CITY PLANNING COMMISSION

- APPLICATION:
- A. Negative Declaration
 - B. Tentative Subdivision Map to create a seven lot condominium subdivision
 - C. Special Permit to develop 320 condominium unit
 - D. Plan Review of 320 condominium units

LOCATION: NW corner Mack Road and Franklin Boulevard

PROPOSAL: The applicant is requesting the necessary entitlements to create a seven lot subdivision to develop 320 condominium units.

SITE PLAN

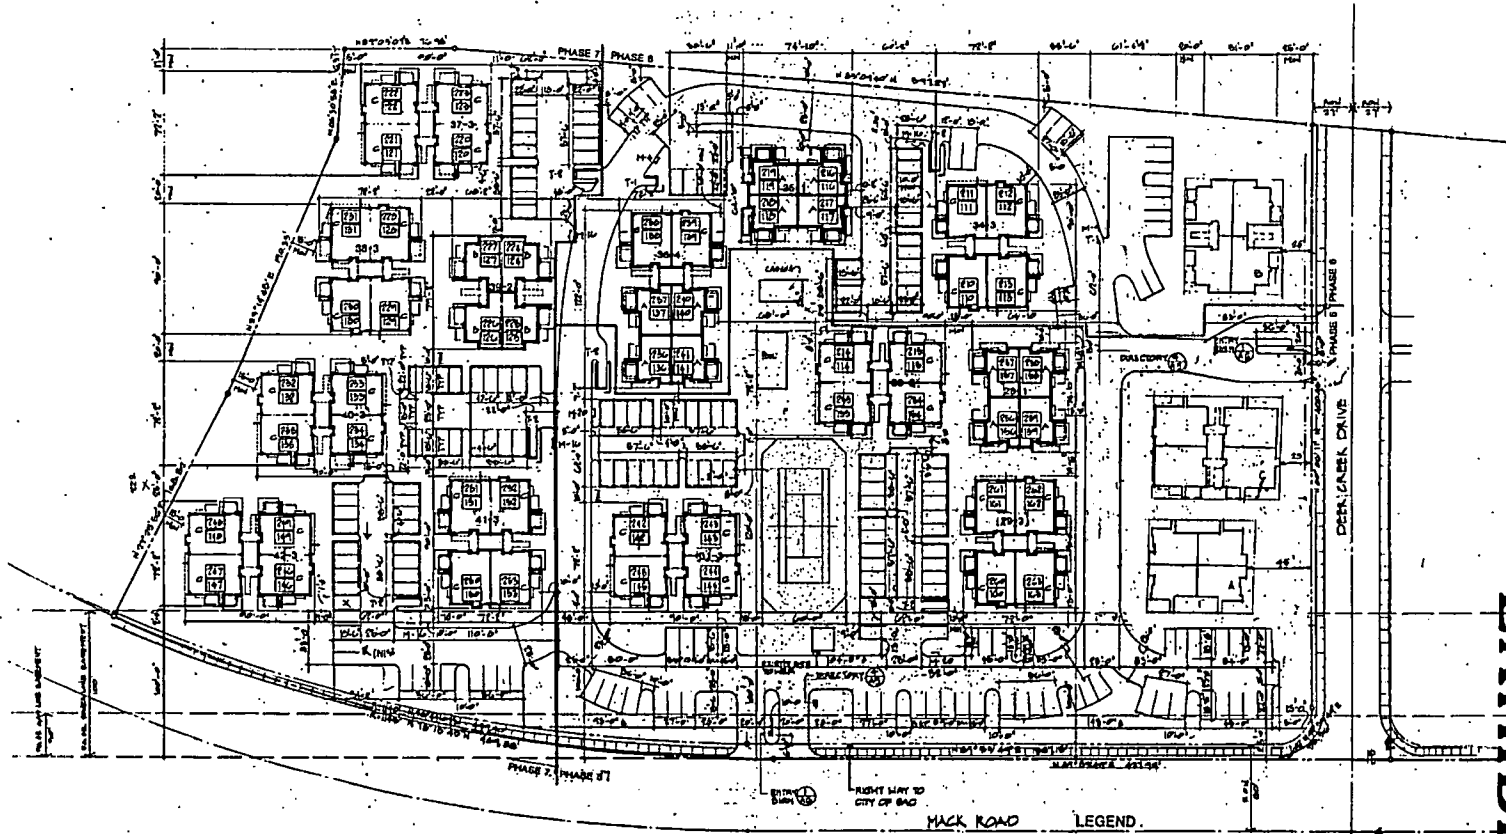
There are no major objections to the overall architecture of the units per se in that the buildings are designed with sufficient relief with the incorporation of bay windows, balconies and off-set building walls. The following site features are suggested to improve the compatibility of the subject site with the adjacent single family subdivision:

- a. Provide a 15 foot landscape setback separating the subject site from the single family properties to the north and west. This area should be intensively landscaped with trees and screening shrubs.

- b. In order to provide a noise buffer between the project's parking areas and access drives, a six foot high solid masonry wall should be installed along the north and west property lines.

In addition, the setback area along Mack and Franklin Boulevard should also be landscaped including a four foot high undulating berm. A 35 foot setback should be maintained along Deer Creek Drive.

- a. Check with Traffic Engineering on location of driveway at Franklin Boulevard. May have to be relocated further south of bridge crossing.
- b. No encroachment will be allowed into levee slope unless approved by City. (Wood retaining wall not acceptable).

- a. The applicant shall submit revised site plans to the Planning Director for review and approval prior to issuance of building permits. The revised plans shall include the following modifications:
 - 1. A minimum setback of 35 feet shall be maintained along Deer Creek Drive.
 - 2. A six foot high solid masonry wall shall be installed along the north and west property lines where the subject site abuts residential properties. This shall be a decorative wall design and it shall be reviewed and approved by the Planning Director.

- b. The applicant shall contact the Traffic Engineer for review and approval of the location of the driveway on Franklin Boulevard.
- c. The applicant shall submit a detailed landscape, irrigation and shading plan to the Planning Director for review and approval prior to issuance of a building permit. The landscape plan shall provide intensive landscaping of all landscape setback areas.
- d. The applicant shall provide a four foot high undulating berm along Mack Road and Franklin Boulevard.
- e. The applicant shall adhere to the residential design criteria as indicated in Exhibit D.
